Planning and Zoning Commission Meeting

Application for a Conceptual Plan Approval – McBee's Coffee & Carwash

Application for a Conceptual Plan Approval – Fairview Crossing

sheet number
A1.1
 drawing type rezoning
 project number 21072-13

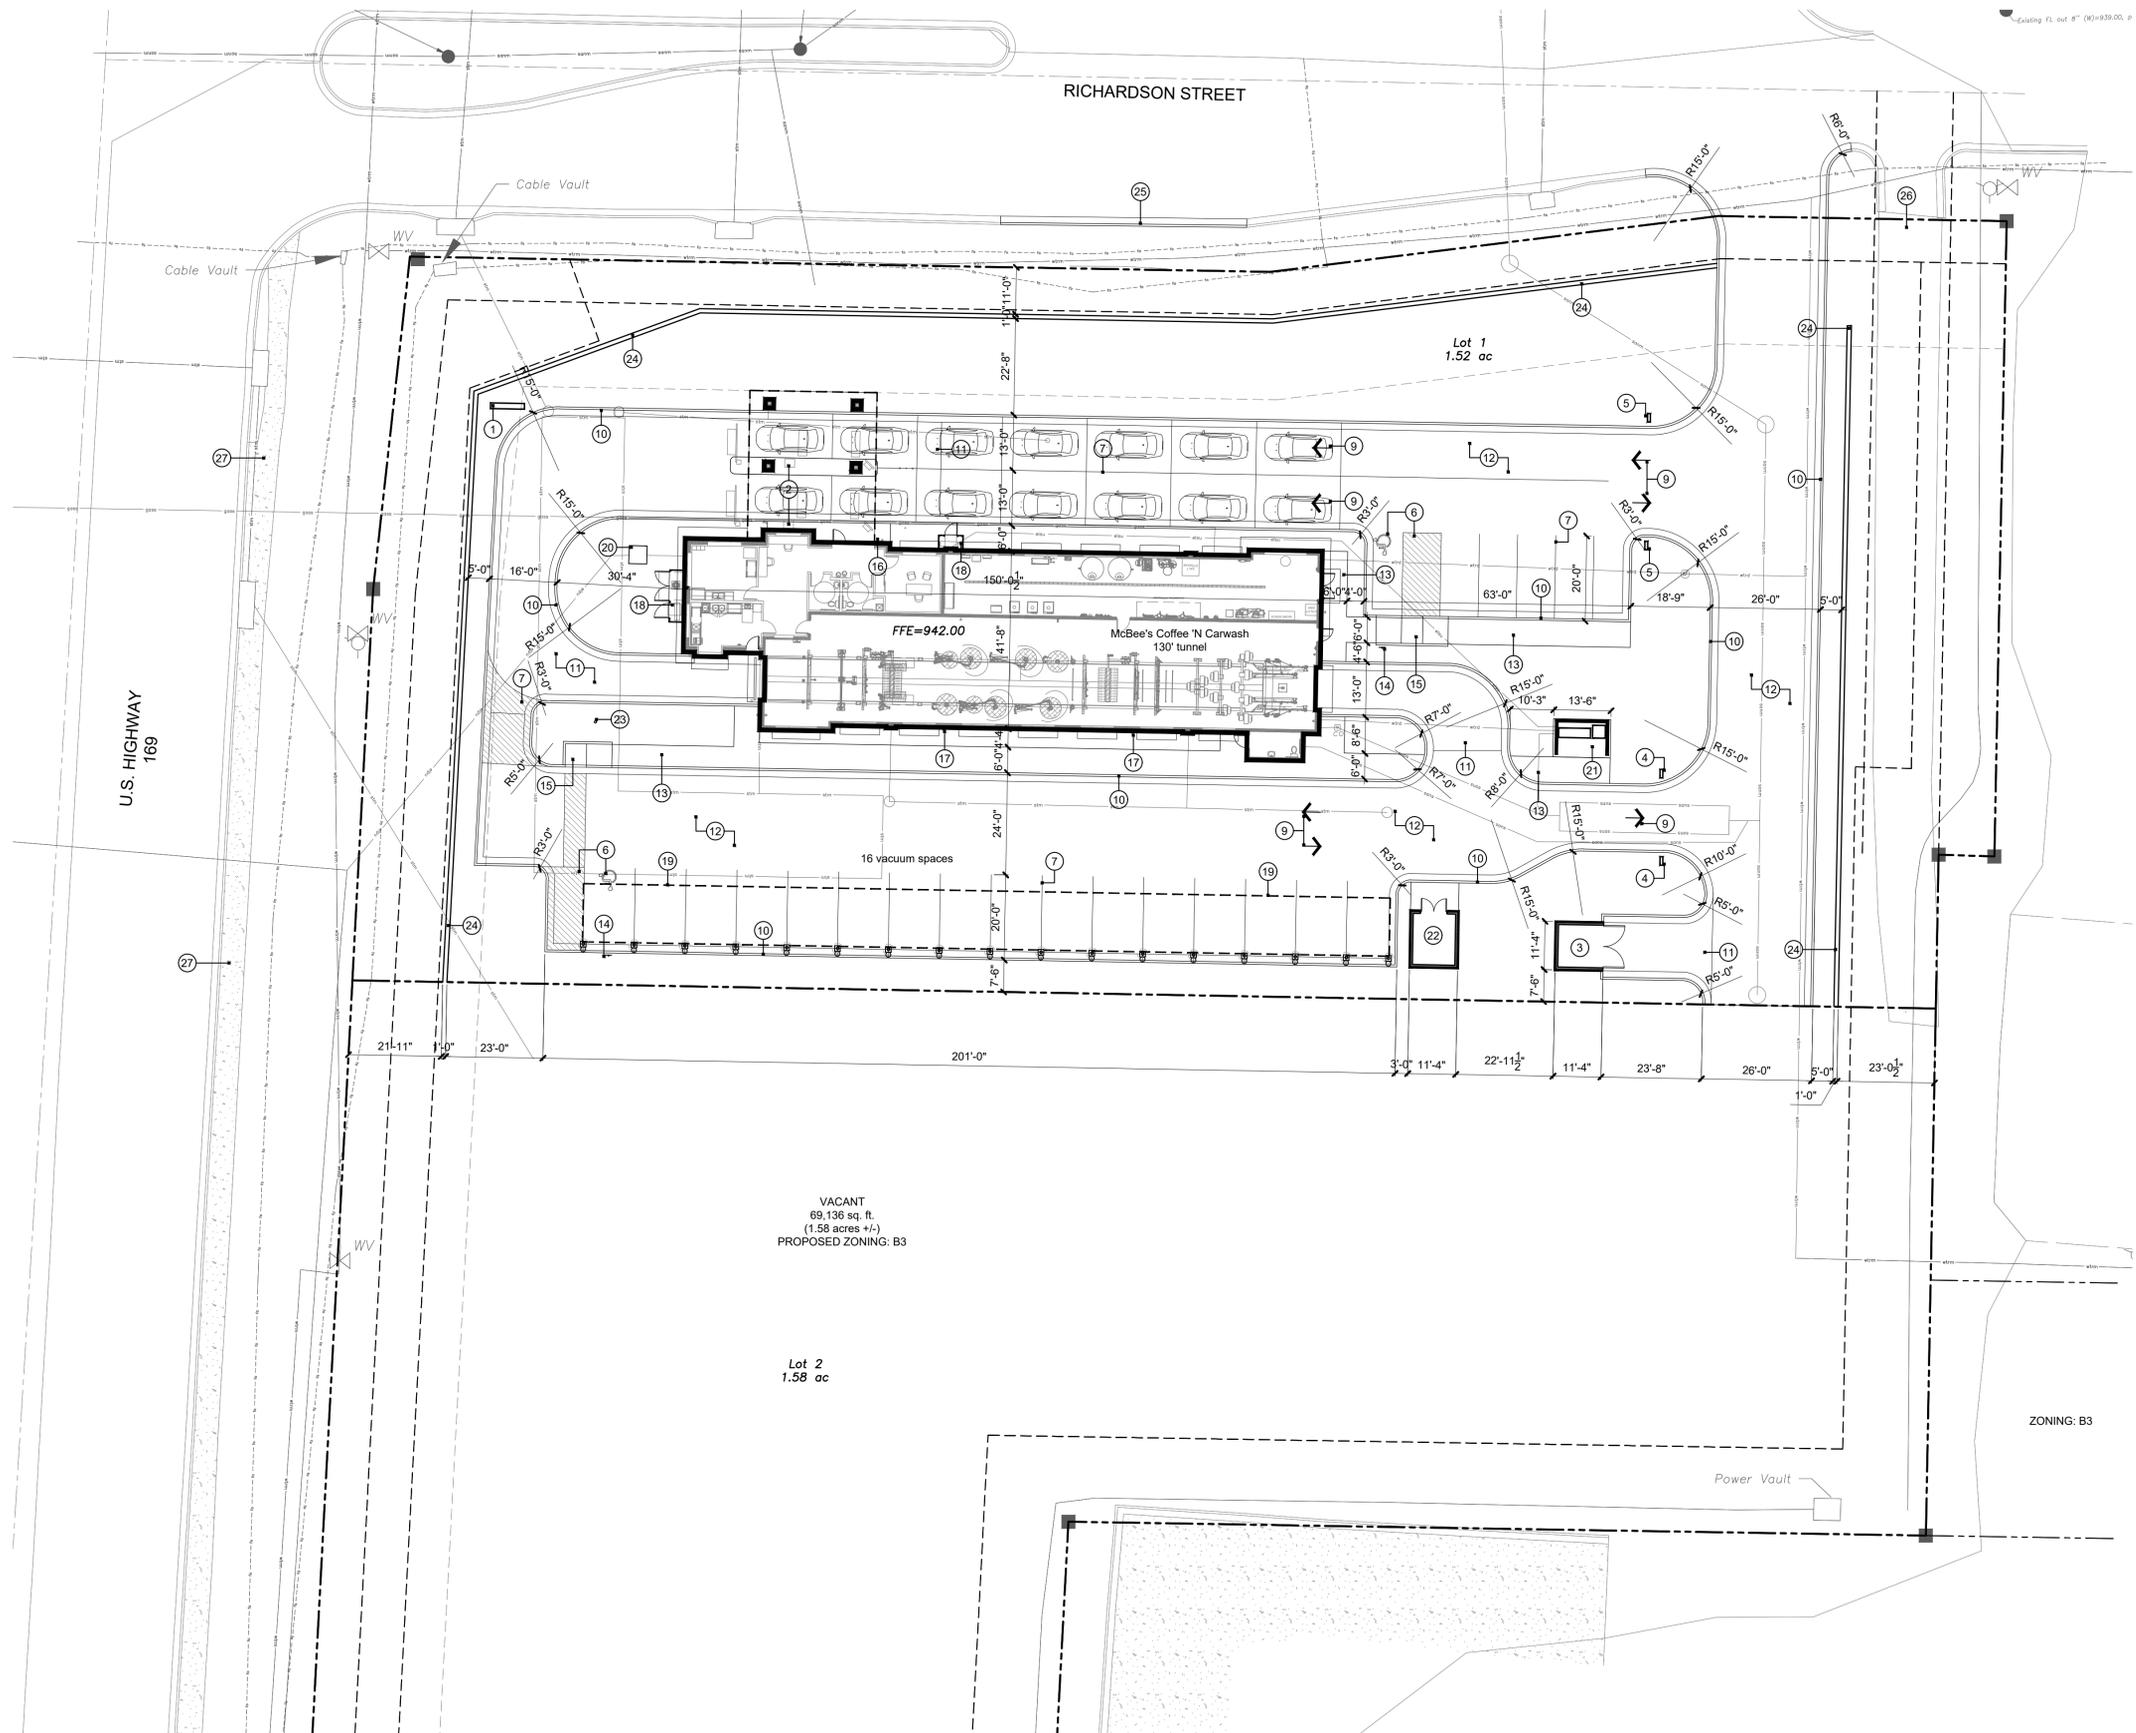
Development placement will ultimately include a retaining wall to separate the hotel lot to the south from access into this project, but grading is overall minimum.

Development is laid out in a fashion to meet the site plan requirements on both lots. The proposed drive thru carwash is the only definitive project, and exceeds the minimum parking standards. The remaining

lot has no definitive use/building, so no calculations can be made. There exists sufficient land to address parking and that lot development will require Site Plan Review to address all aspects.

Development leaves ample spacing between the proposed buildings, as well as the existing facilities.

The Development will include landscaping as shown on the submitted plans for the car wash site, and the vacant lot 2 will be required to comply with regulations in place at the time of development.

PLANNED OVERLAY DEVELOPMENT PLAN
 SITE PLAN

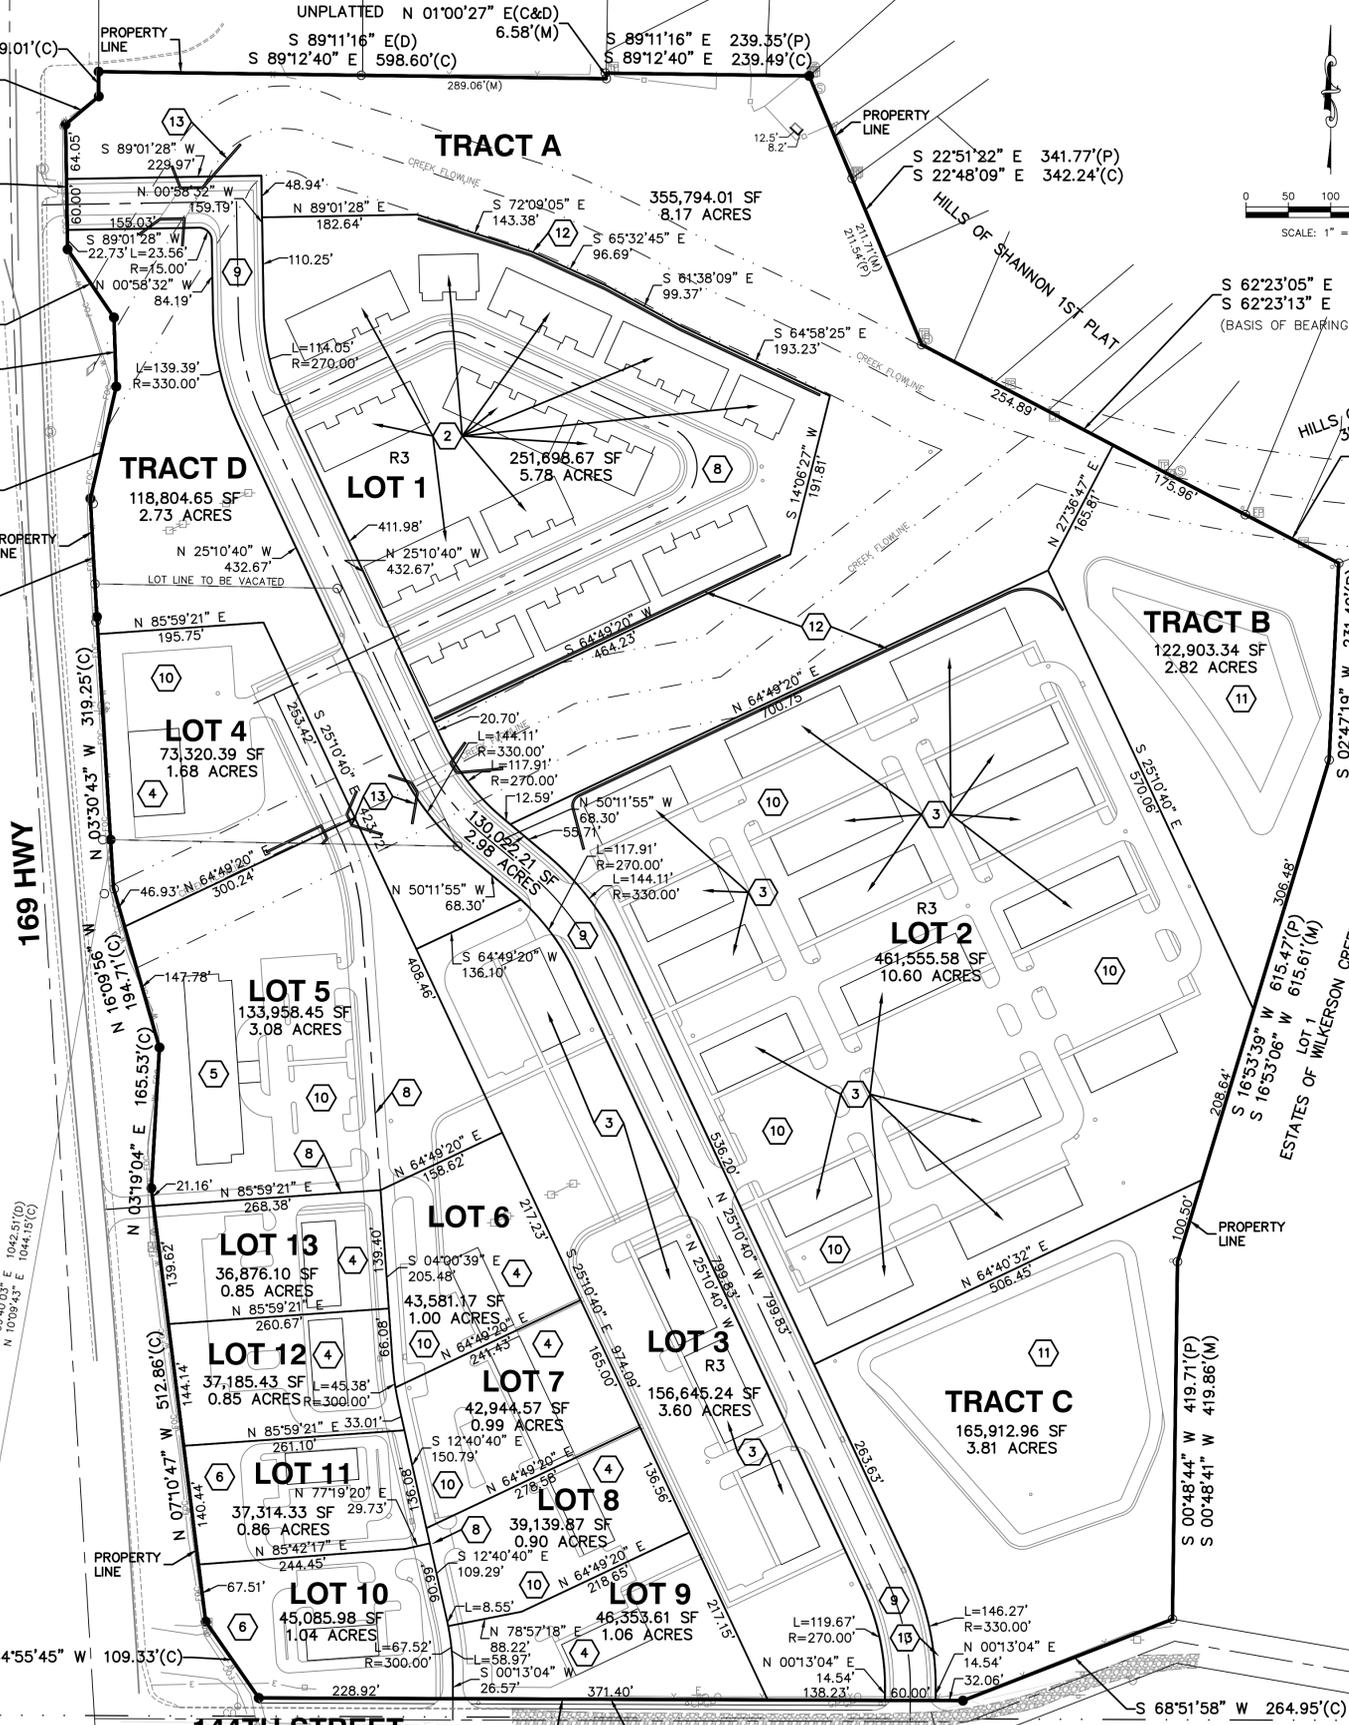
Development is laid out in a fashion to meet the site plan requirements and includes sufficient parking as shown on Page 1 of the submittal. Any minor variations to building size could impact the required parking, but in no event will a tenant be able to increase a building footprint or change a use without adjusting parking to meet these requirements.
